MAINE TURNPIKE AUTHORITY

ADDENDUM NO. 1

CONTRACT 2016.06

GUIDE SIGNING UPGRADES

SHEET NUMBER: 2

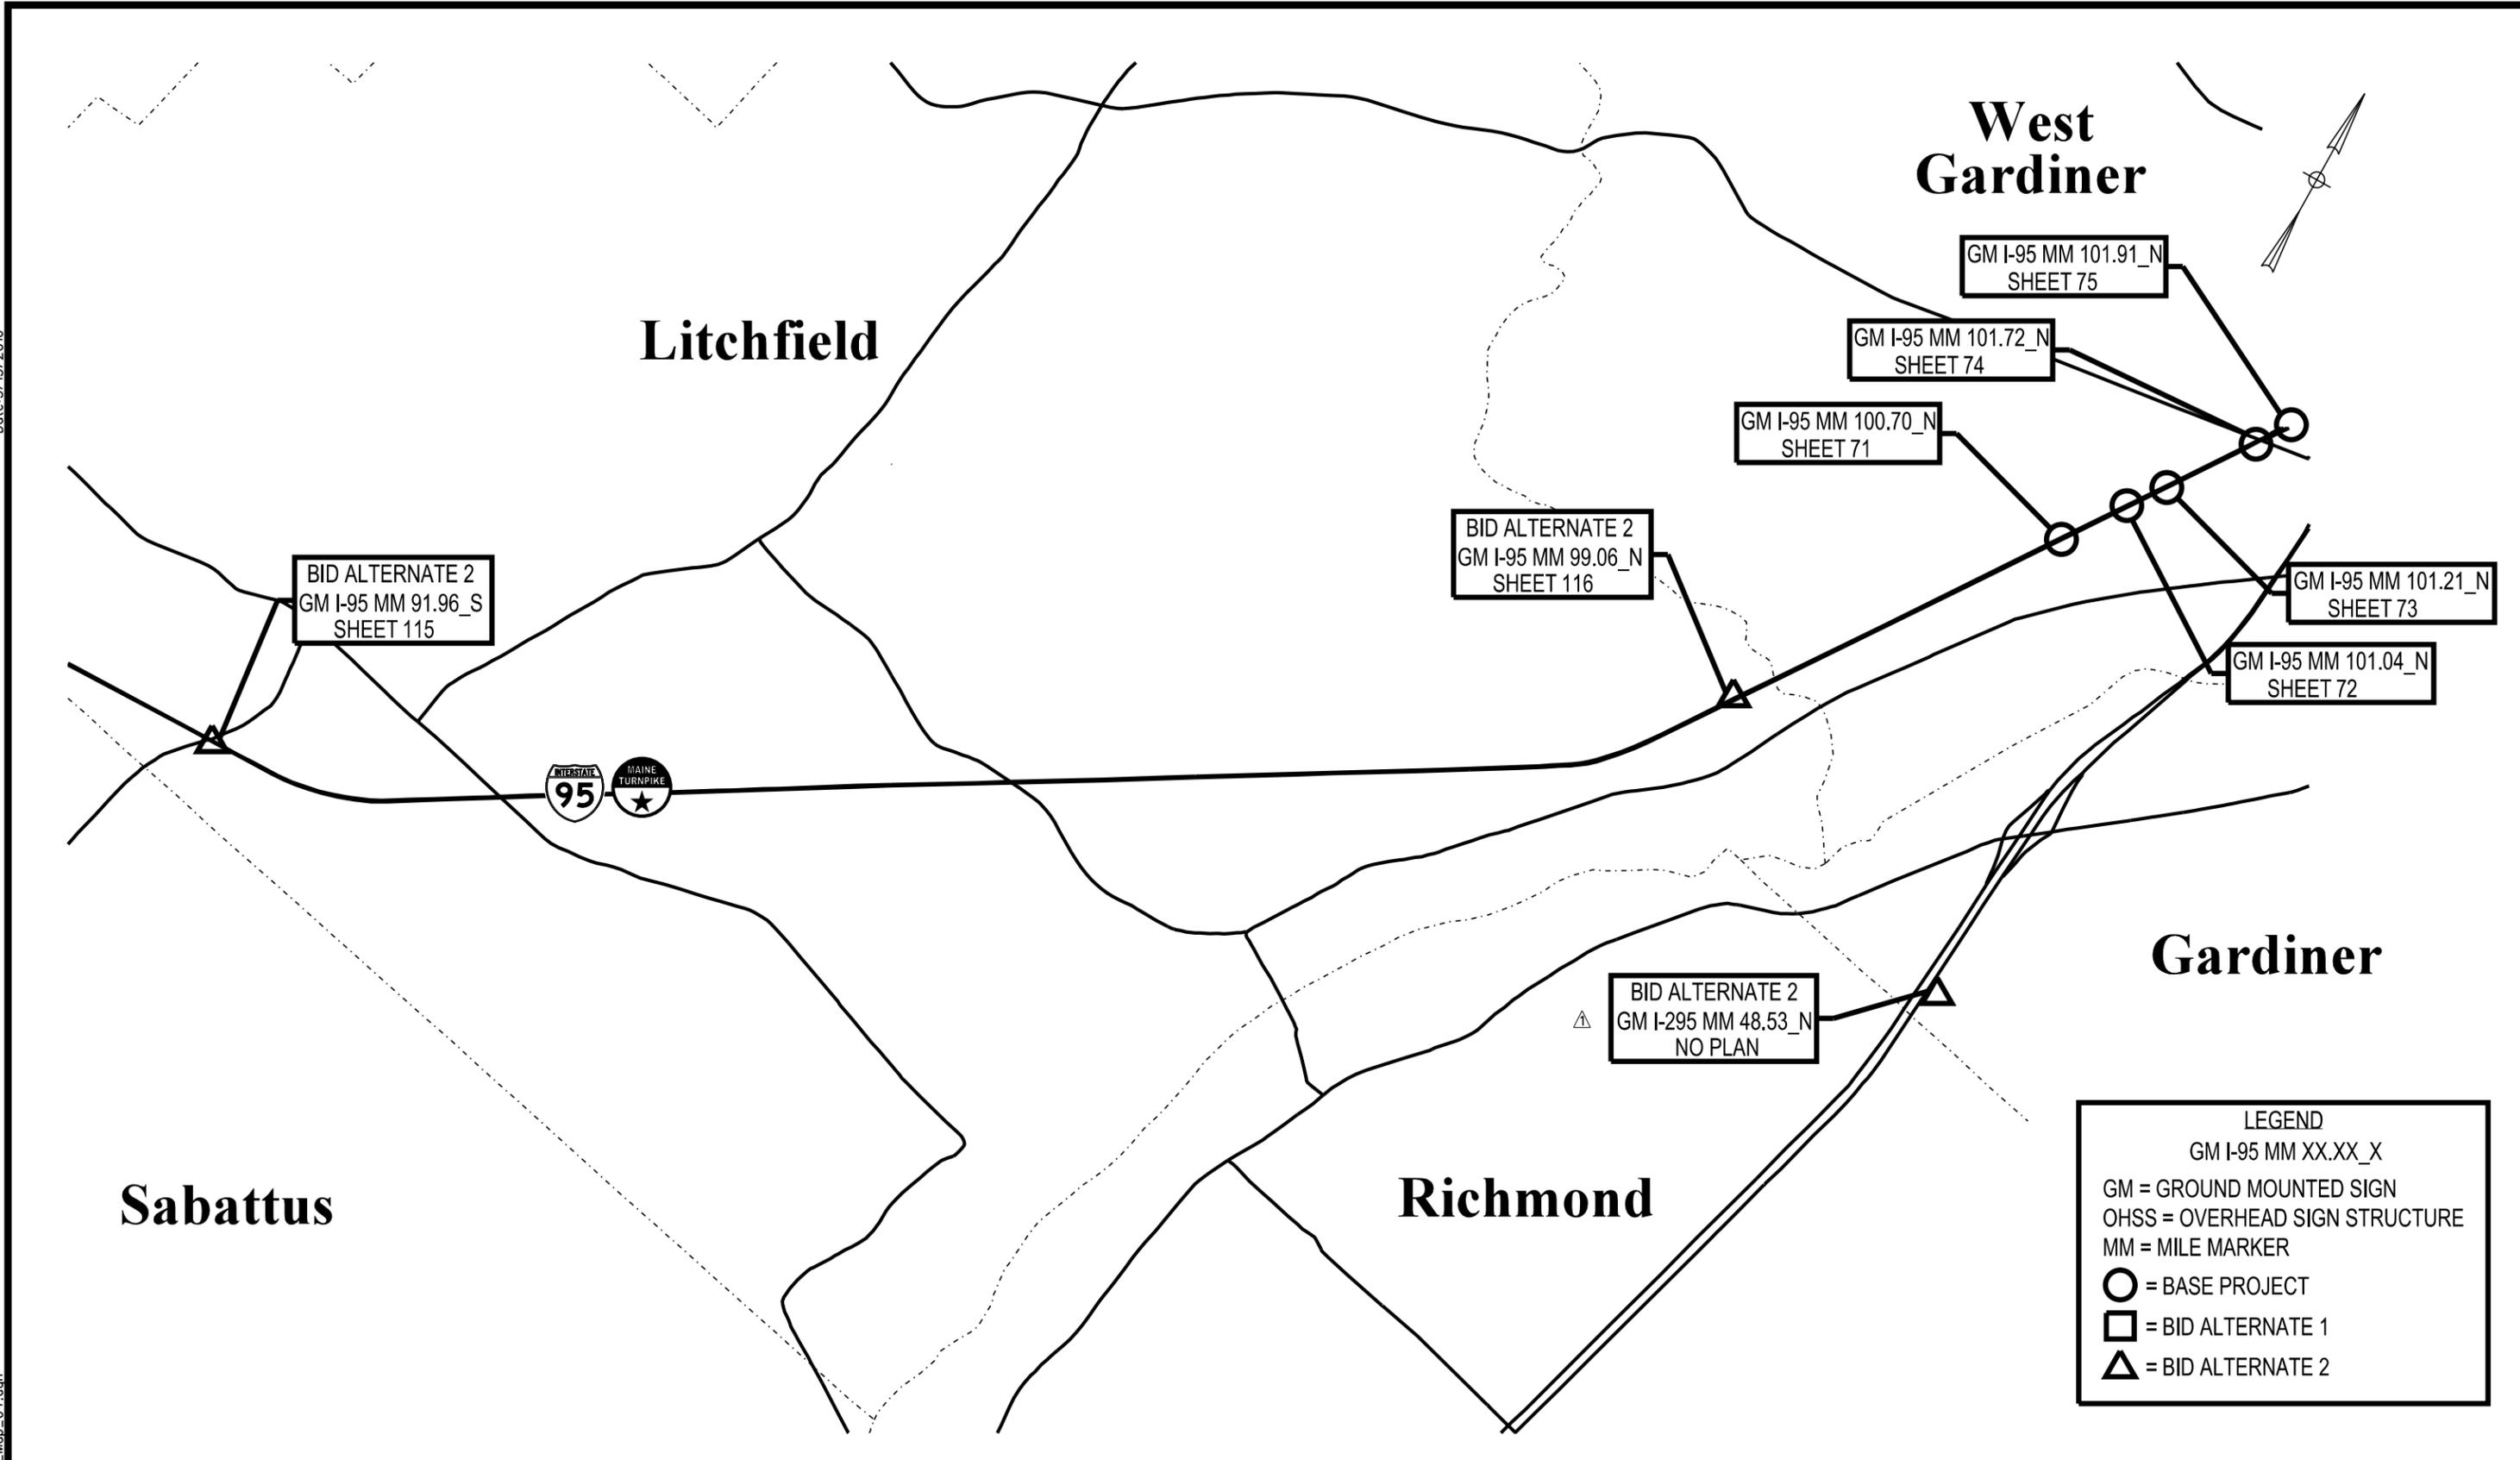
Question 2: Plan Sheet 2, Sign Supports and Foundations Note #4 references unsuitable soil conditions. Is the Contractor required to provide a structural design for a new cast-in-place foundation?

- If the Contractor encounters unsuitable soils (including but not limited to organic materials, peat, clay, or previously disturbed soils) within the limits of the foundation excavation, the Contractor shall remove the unsuitable materials to the limits directed by the Resident. Alternatively, the Authority has the right to relocate the proposed foundation to avoid the unsuitable soils.

Response: Upon notice by the Contractor of unsuitable soil conditions as verified by the Resident, the Authority may elect to relocate the sign or provide an alternative foundation design to the Contractor. Plan Sheet 2, Sign Supports and Foundations Note #4 has been revised to reflect this change.
